**Drain:** SPRINGMIL VILLAGES DRAIN **Drain #:** 268  
**Improvement/Arm:** THE MEADOWS - SECTION 4A  
**Operator:** SLM / JON **Date:** 5-19-04  
**Drain Classification:** Urban/Rural **Year Installed:** 1998

RE: Springmill Villages Drain, The Meadows Section 4A Arm

Re: Springmill Villages Drain:  
 The Meadows at Springmill Villages Sec 4A

# THE MEADOWS AT SPRINGMILL VILLAGES SECTION 4A & 4B

**STORM SEWER PLAN & PROFILE**

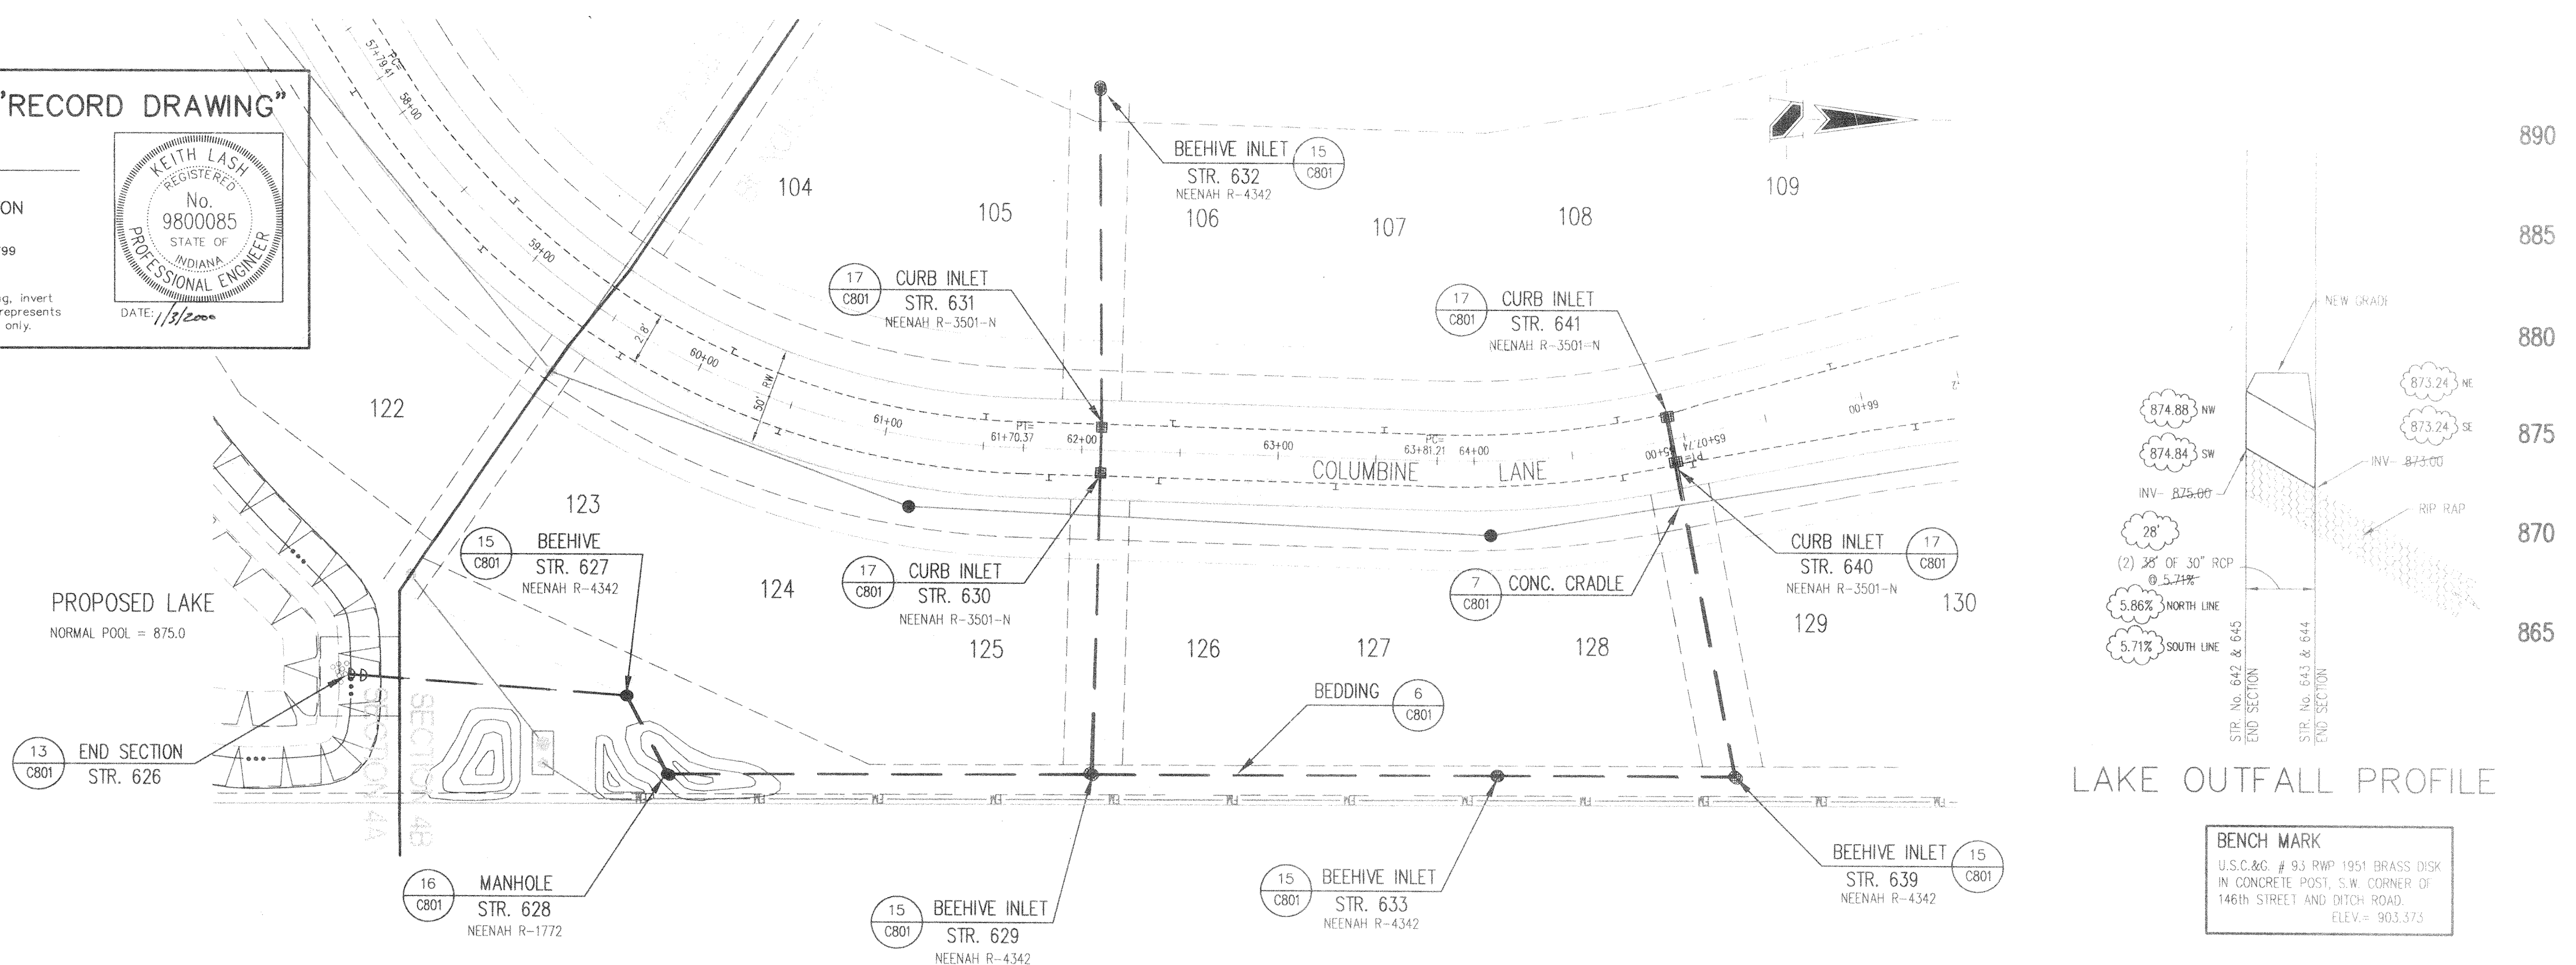
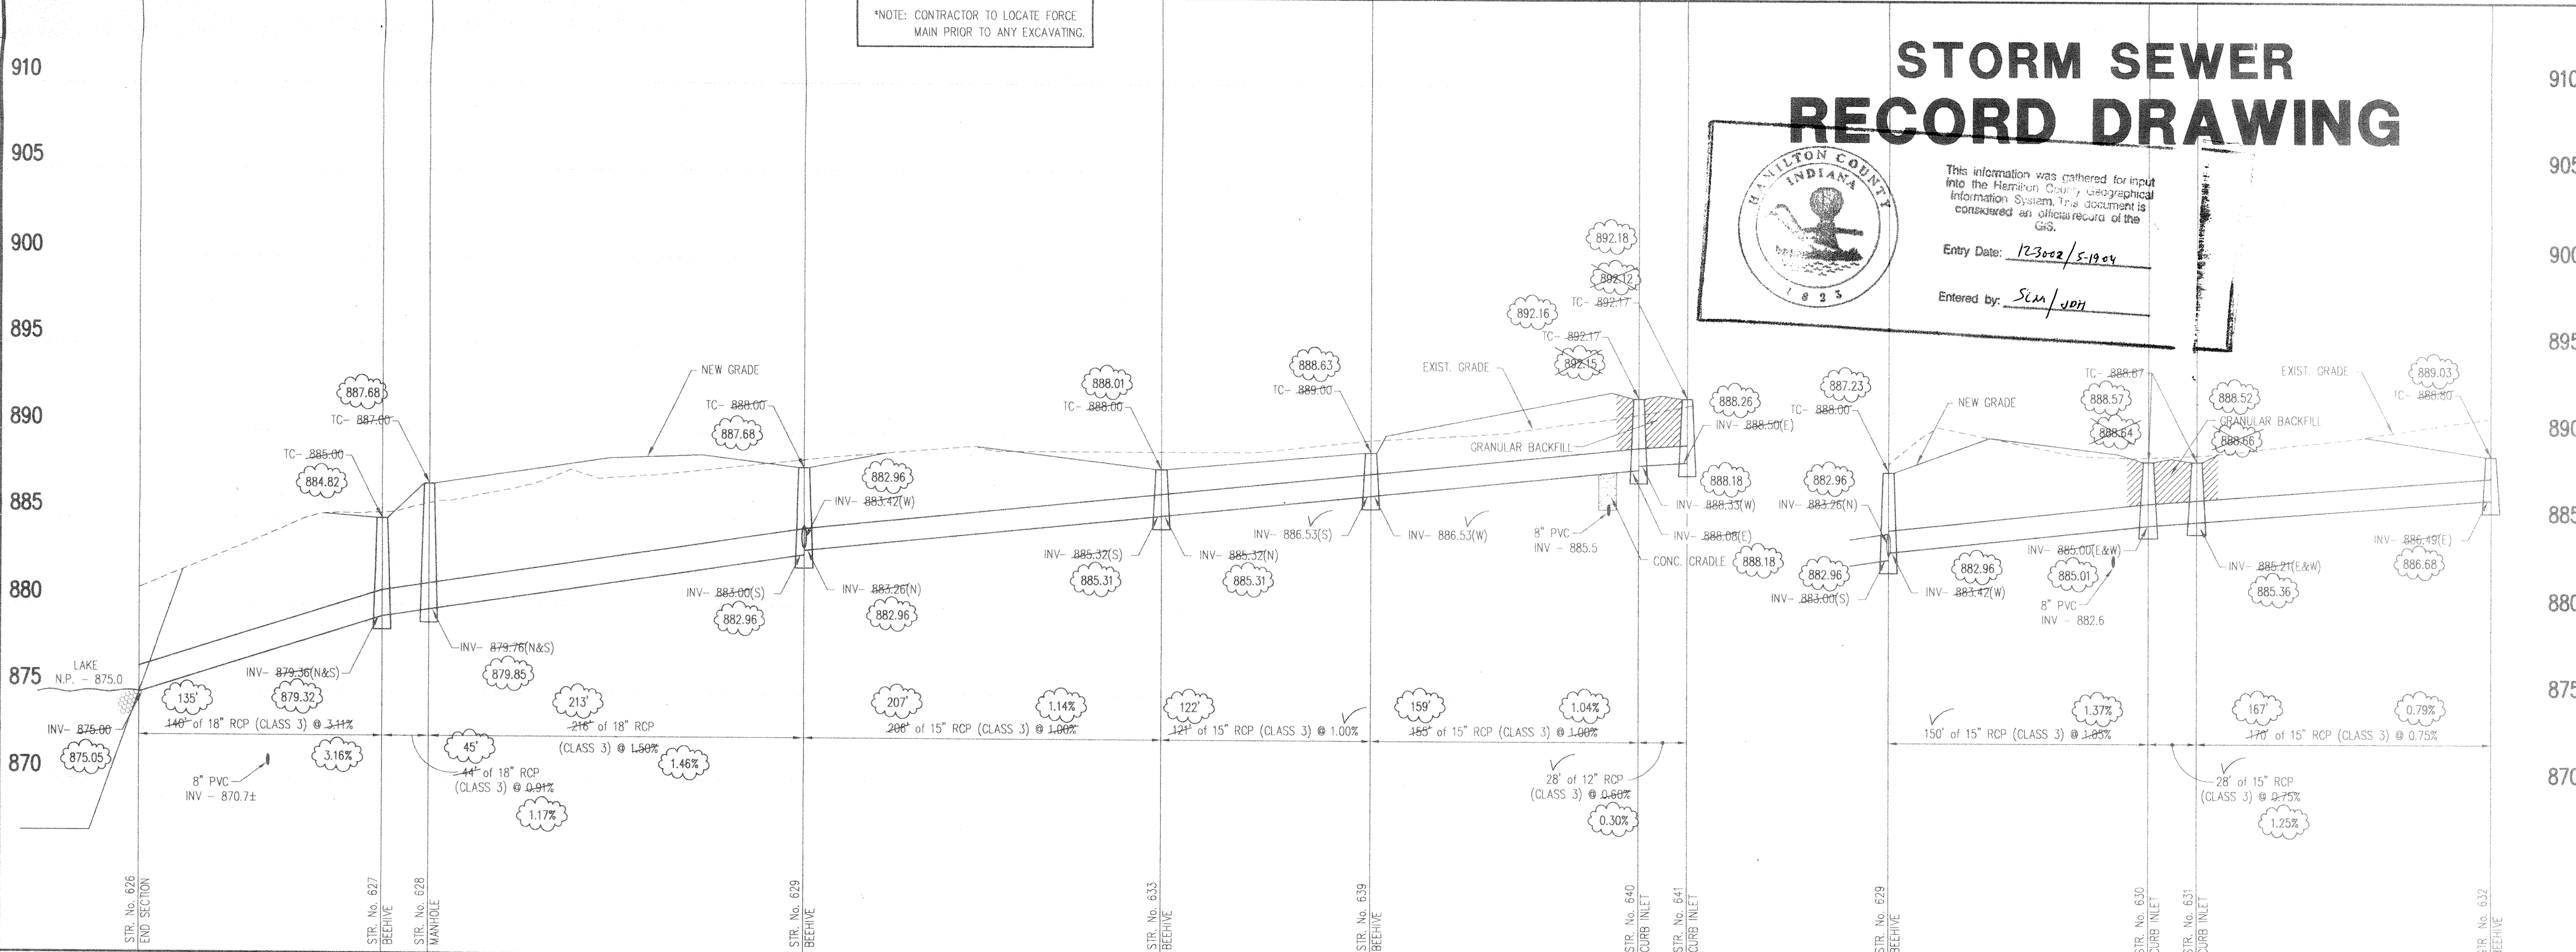
- Revisions
- 3-14-96 REVISED PIPE SLOPE & NEW GRADE D.T.R.
  - 10/19/98, MC, REVISED PER HAMILTON CO. SURVEYOR AND HIGHWAY DEPT.
  - 12/18/98, BET, REVISED LOCATION OF MANHOLE # 629
  - 06/21/99, BET, RECORD DRAWING
  - 12/20/99, MC RECORD DRAWING, REVISED ASBUILT ELEV. STR. 640,641,630 AND 631

**Map Correction-Field Verification**

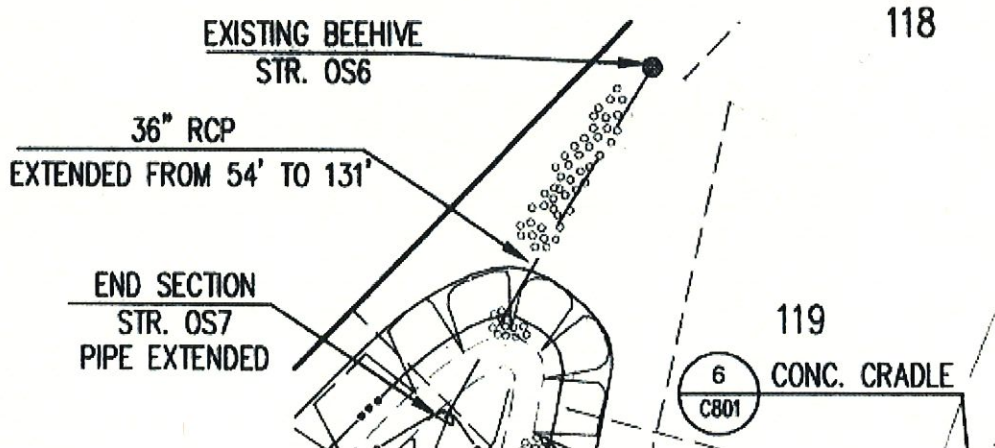
**Notes & Sketch:** 54 feet of existing pipe 36" RCP was not included in the Final Report. This was between structures OS6 to outlet. This was extended to structure OS7.
